subject Sign Permit # 11, Baum's Motel

SIGN PERMIT

4' x 4' Plastic Illuminated

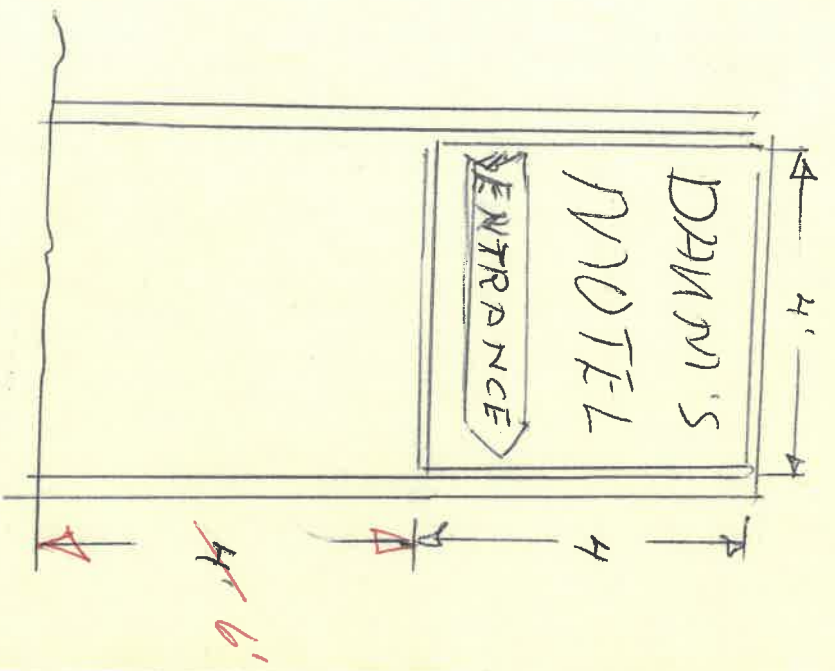
A field inspection has revealed that the minimum vert. distance between existing grade & the bottom edge of sign of 6 feet has not been complied with. We suggest your attention to this matter A.S.A.P.

The minimum vert distance between existing grade & the bottom edge of sign shall be 6 ft. Wayne R. Zimmerman
Signature of Applicant
